Re: Comments on PSE Draft CEIP (docket UE-210795)

The Washington Clean Energy Coalition, an organization that includes environmental organizations that have participated in the development of PSE's Integrated Resource Plans over many years, is concerned about defective CBI methodology in PSE's Draft Clean Energy Implementation Plan. There appears to be evidence of biased analysis by PSE that produces results that are in the best of interest of the company, not ratepayers nor the environment.

*Lake Hills substation with potential Tesla Megapack battery locations shown in orange*

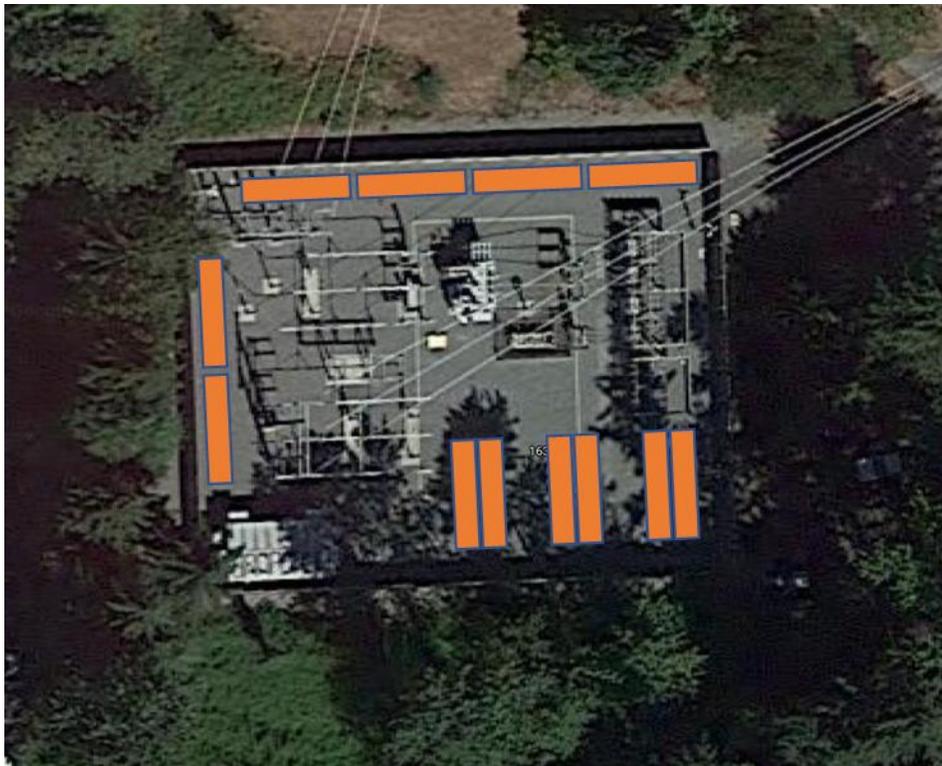
For example, consider the Lake Hills substation in East Bellevue, which contains four circuits serving a total of 5,500 customers in 2020. The substation has enough extra space to accommodate 12 Tesla Megapack batteries, capable of delivering a total of 18 MW for two hours. That would be enough to cover two hours of the 2024 peak demand on the Lake Hills substation predicted in 2018 WECC base cases (12 MW in a “heavy summer” scenario, 18 MW in a “heavy winter” scenario). The following photo shows a possible configuration of the batteries with standard spacing. (The dimensions of the Lake Hills substation are 135' x 100', and each Megapack is 23.5' x 5.5'.)

Although there is room for 12 Megapacks, it would be expensive to use batteries to cover 100% of the substation’s maximum load. Instead, consider the benefit of covering summer peak demand for any one of the substation’s circuits for two hours. That would require only four batteries at a cost of \$4.5 million. The batteries would provide some protection from power outages, some resiliency during emergencies, and cost savings by time shifting cheap renewable energy to serve peak hours.
